TECHNICAL SERVICE BULLETIN

Transmission Clutch Fluid Overheating During Track Use - Vehicles Equipped With Parallel Coolers Only

18-2391

Ford 2017 Ford GT

Figure 2 - Parallel

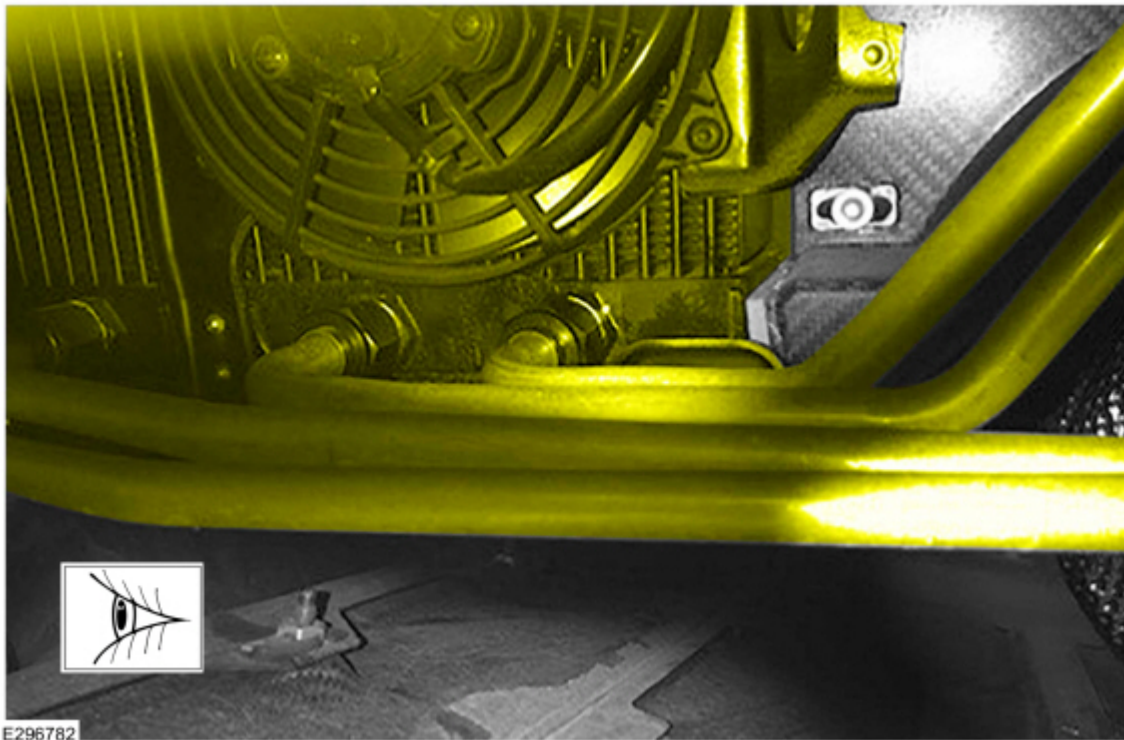
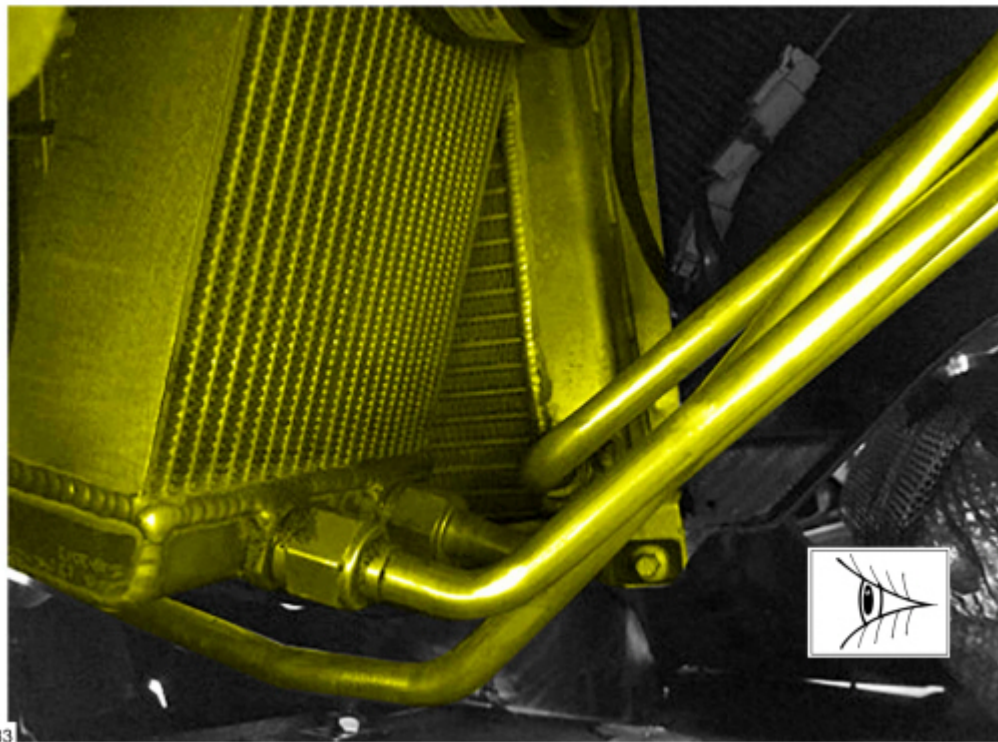
1. Inspect the factory equipped transmission gearset and clutch cooler by looking thru the rear fascia grille opening at the left side of the rear bumper cover. (Figure 1) Is the vehicle equipped with a perpendicular transmission gearset and clutch cooler? (Figure 2-3)

(1). Yes - this article does not apply. Refer to Workshop Manual (WSM), Section 307-02 for normal diagnostics.

(2). No - proceed to Step 2.
